**Rezoning Application:** PD 24-0932  
**Zoning Hearing Master Date:** October 15, 2024  
**BOCC Land Use Meeting Date:** December 10, 2024

**1.0 APPLICATION SUMMARY**

**APPLICATION NUMBER: PD 24-0932**

**2.3 Immediate Area Map**

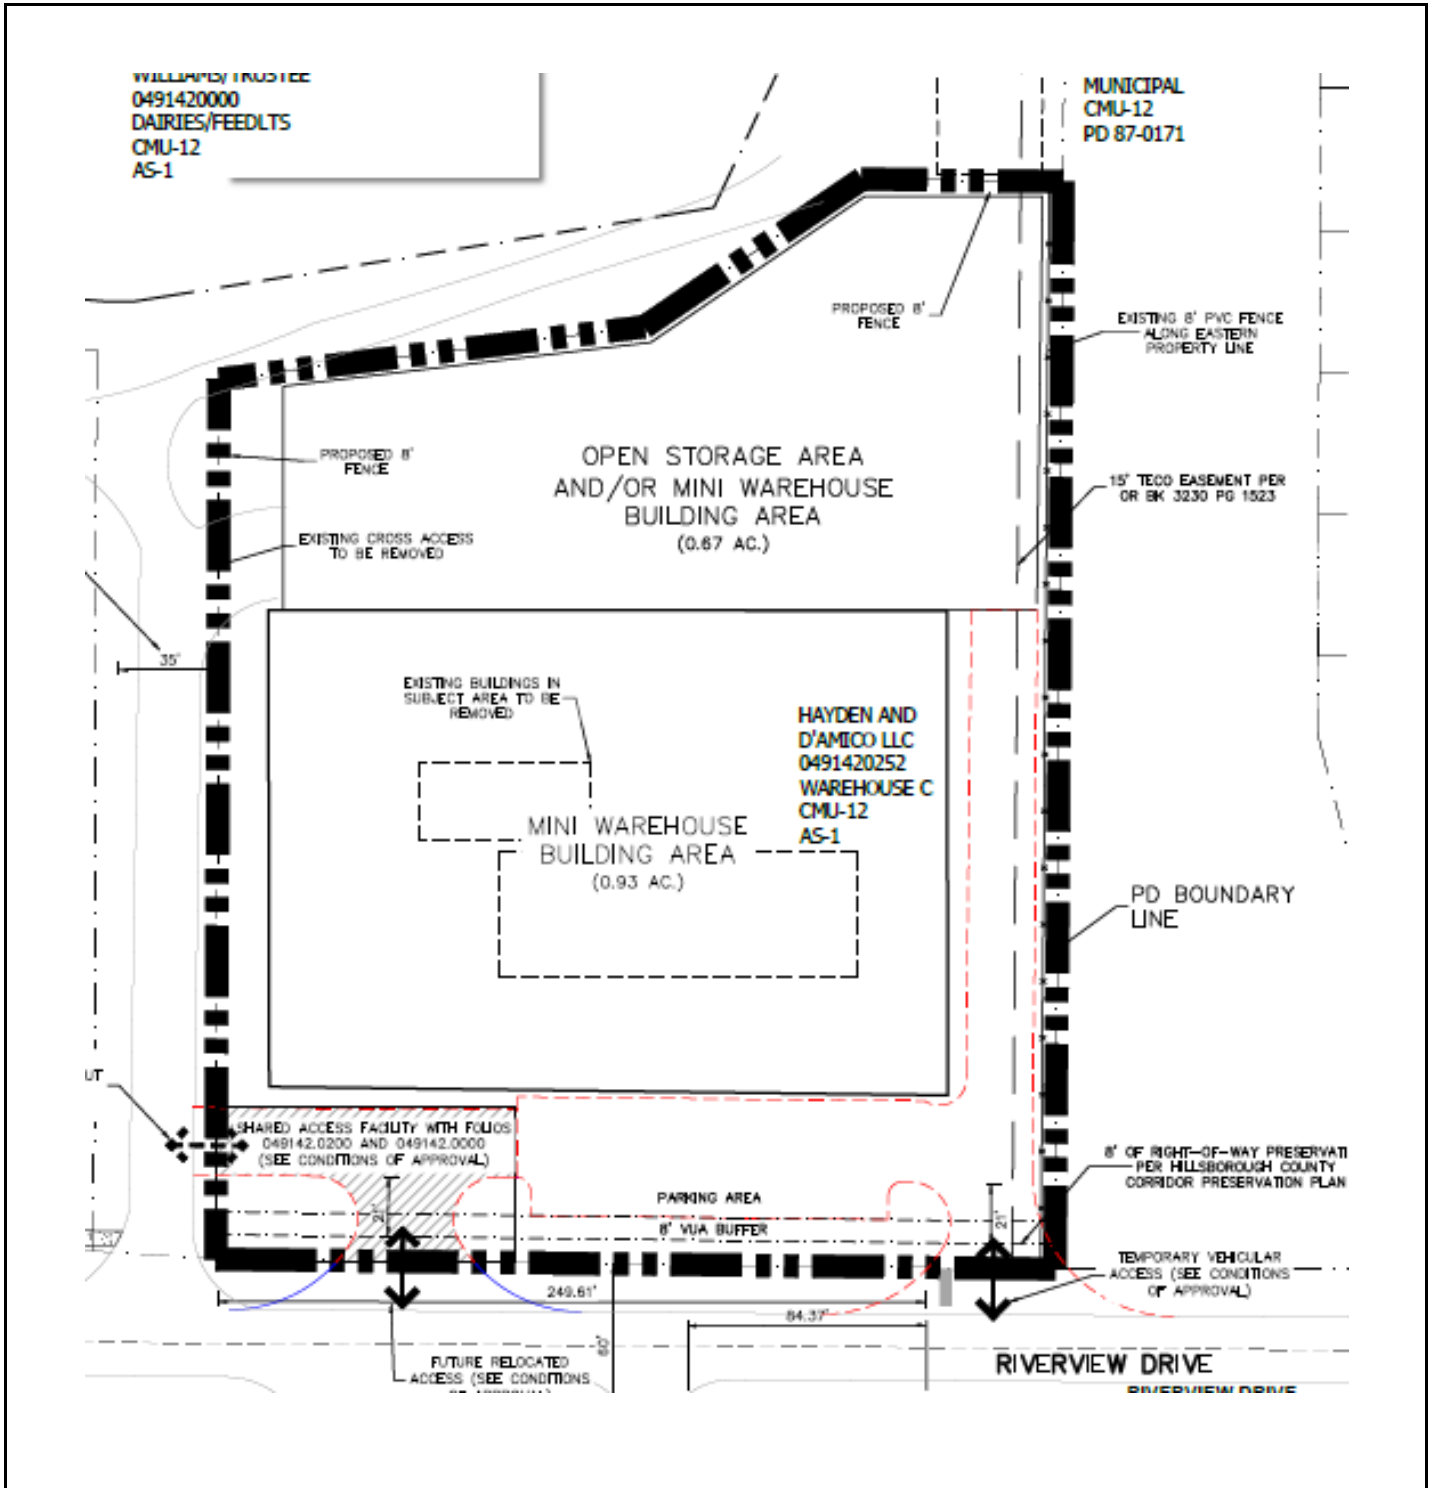
Prior to Site Plan Certification the following shall be amended:

- Correct the Mini-warehouse acreage under “Proposed Use” from 0.93 ac. to 2.34 ac. for Mini-warehouse.
- Clearly delineate with “dotted lines” area where Open Storage shall be permitted.
- Shift the internal driveway westward off the 15’ TECO easement area.
- Remove 8’ fence shown on site plan along the western property boundary.

REVISION DATE:  10/17	<b>TRANSPORTATION TECHNICAL MANUAL</b>	 <b>Hillsborough County Florida</b>	<b>LOCAL &amp; COLLECTOR RURAL ROADS (2 LANE UNDIVIDED) TYPICAL SECTION</b>	DRAWING NO. <b>TS-7</b>
				SHEET NO. 1 OF 1

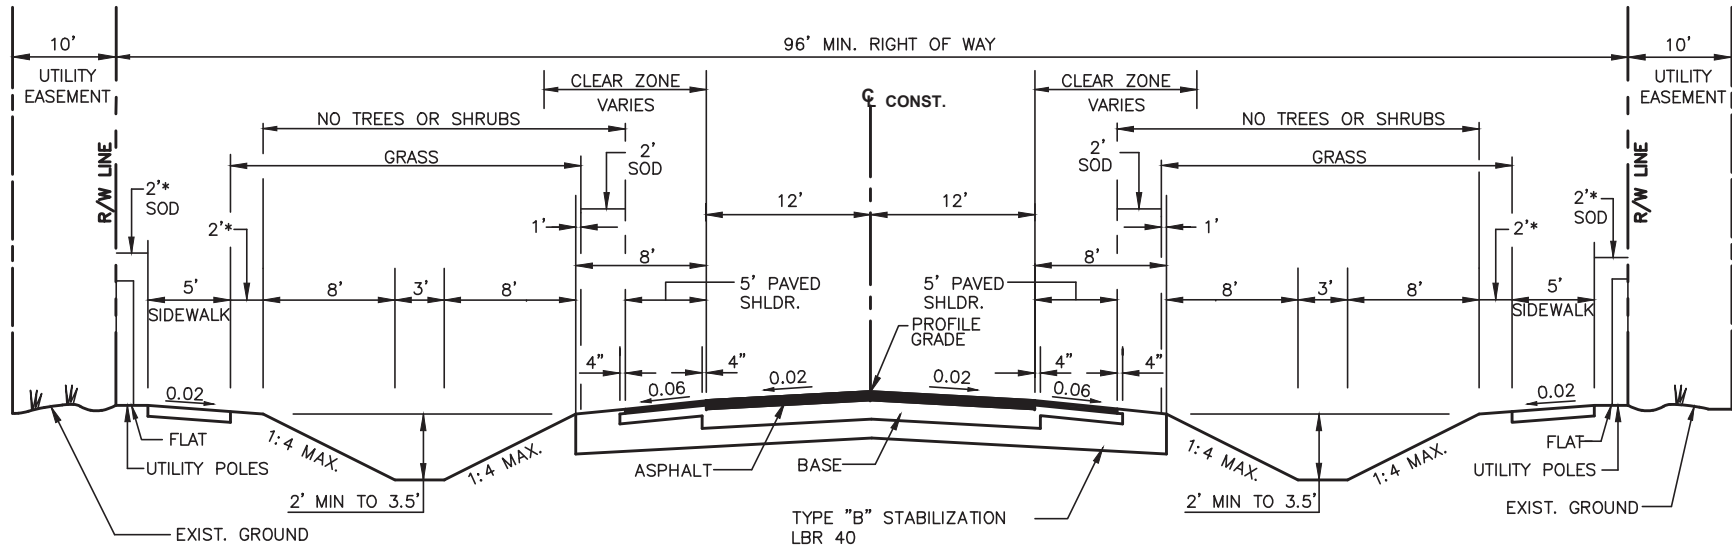
Riverview Drive currently has 11-foot travel lanes. According to the Florida Green Book, on a suburban roadway where the speed limit is between 40 and 45 mph, 11-foot lanes may be used. The posted speed limit on Riverview Drive is 45 mph. The existing 11-foot travel lanes help keep the speed down and help provide a safe section that serves the neighborhood. Given the information outlined in this section, the existing roadway section would not be detrimental to the public health, safety and welfare of the motoring public.
